FINAL ENVIRONMENTAL IMPACT REPORT

AND RESPONSES TO PUBLIC COMMENTS

Doheny Ocean Desalination Project

SOUTH COAST WATER DISTRICT

EXHIBIT 4.7-2: Schools within 0.25 Miles of the Proposed Project

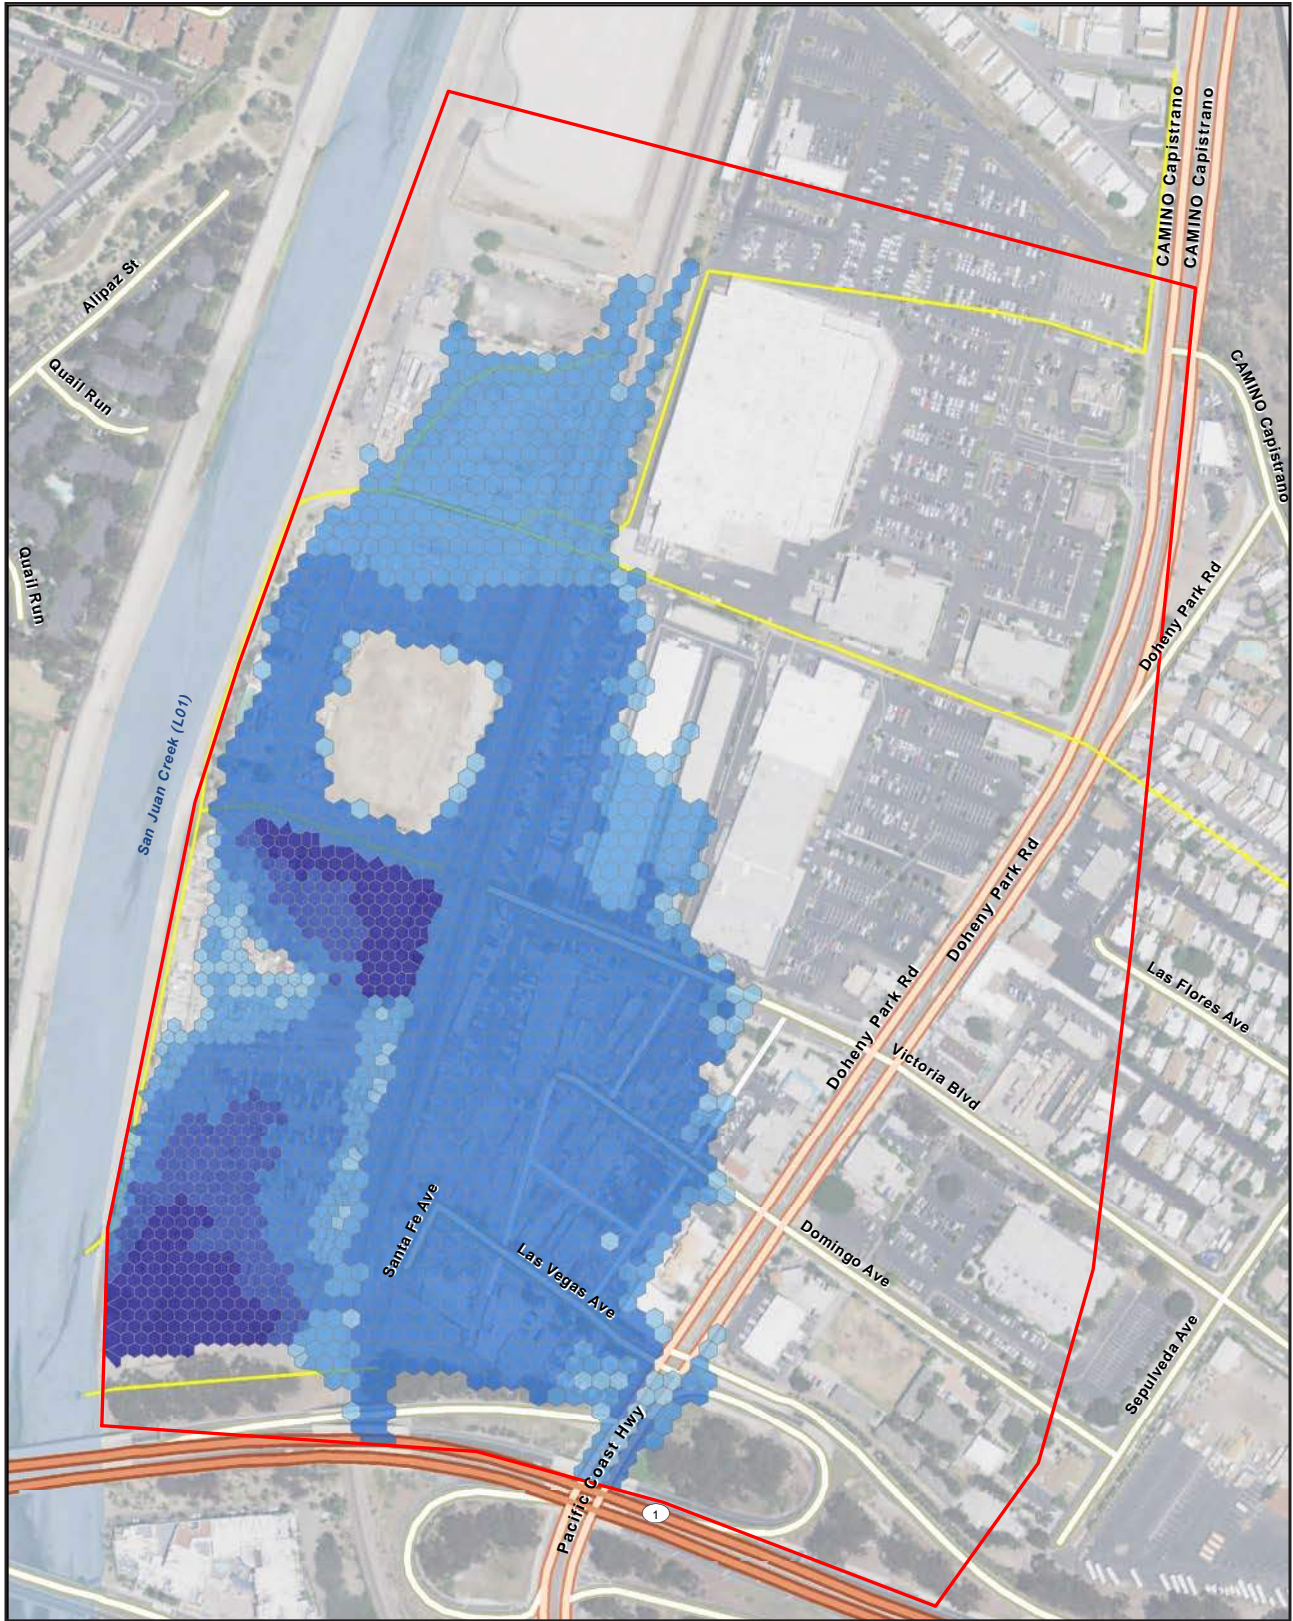
5. The OCHCA noted that the study areas depicted on Exhibit 4.7-1 do not align with those depicted on Figure 4.7-2. For the purpose of this review the OCHCA evaluated the boundaries presented on Exhibit 4.7-1. If the boundaries presented on Exhibit 4.7-1 are in error, please notify the County of Orange.

The boundaries on Exhibit 4.7-1 are correct. Exhibit 4.7-2 will be modified to reflect the correct boundary for the Intake Study Area and Conveyance Study Area which apparently shifted during the printing process. Refer to Section 3, *Draft EIR Errata*.

Exhibit 4.7-2 has been modified and is included in Section 3, *Draft EIR Errata*.
